Access Compliance Report Public Rights-of-Way (Curb Ramps)

Main Street: RAINIER_DR **Cross Street:** ROSALIND_DR **Location:** NW

ADA ID: RPRK211006152304 **Ramp Type:** Type 1 - Perpendicular Diagonal Initial Pass/Fail: Fail **Overall Compliance:** No **Severity Score:** 15

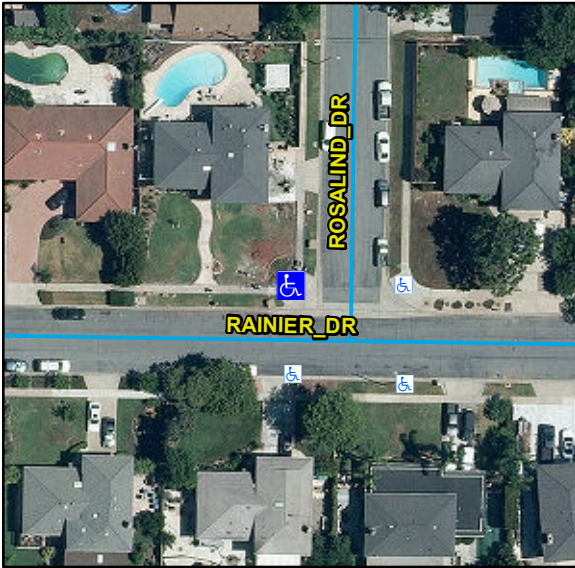
Compliance	Description	Data	Compliance	Description	Data
N/A	Ramp Length (in)	133	N/A	Flare Type LT	
Yes	Ramp Width (in)	48			N/A
No	Ramp Run Slope (%)	9.6	N/A	Flare Slope LT (%)	N/A
Yes	Ramp Cross Slope (%)	0.8	N/A	Flare Traversable LT	N/A
N/A	Landing Present	N/A	N/A	Flare Type RT	
N/A	Landing Length (in)	N/A			N/A
N/A	Landing Width (in)	N/A	N/A	Flare Slope RT (%)	N/A
N/A	Landing Run Slope (%)	N/A	N/A	Flare Traversable RT	N/A
N/A	Landing Cross Slope (%)	N/A	N/A	DWS Provided	N/A
N/A	Landing Movement Obstructed?	N/A	N/A	DWS Contrast	N/A
	Landing Movement Type	N/A	N/A	DWS Length (in)	N/A
N/A	Landing Shared	N/A	N/A	DWS Full Width	N/A
N/A	Clear Space	Yes	N/A	DWS Offset Left (in)	N/A
N/A	Clear Space To Crosswalk (in)	N/A	N/A	DWS Offset Right (in)	N/A
N/A	Marked Crosswalk 1	No	N/A	Marked Crosswalk 2	No
	Crossing 1 Direction	S		Crossing 2 Direction	E
	Marked Crosswalk 1 Width (in)	N/A		Marked Crosswalk 2 Width (in)	N/A

N/A	Ramp Inside Crosswalk 1	N/A	Yes	Ramp Inside Crosswalk 2	N/A
	Crossing 1 Slope (%)	7.5		Crossing 2 Slope (%)	1.2
	Crossing 1 Cross Slope (%)	2.6		Crossing 2 Cross Slope (%)	0.8
N/A	Gutter Ponding	N/A	No	Curb Slope	13.5
Yes	Gutter Lip Height (in)	0		Road Run Slope (%)	1.4
N/A	Gutter Run Slope (%)	N/A		Road Cross Slope (%)	6.2
N/A	Gutter Cross Slope (%)	N/A			
Yes	Overall Surface Condition:	Acceptable	No	Perp Joint Present	No
	Cross Gutter Present?	Yes		Spandrel Present?	Yes
	Replace Cross Gutter?	No		Replace Spandrel?	No

Possible Solutions:
Remove & Replace Curb Ramp With Two New Directional Ramps or Equivalent.
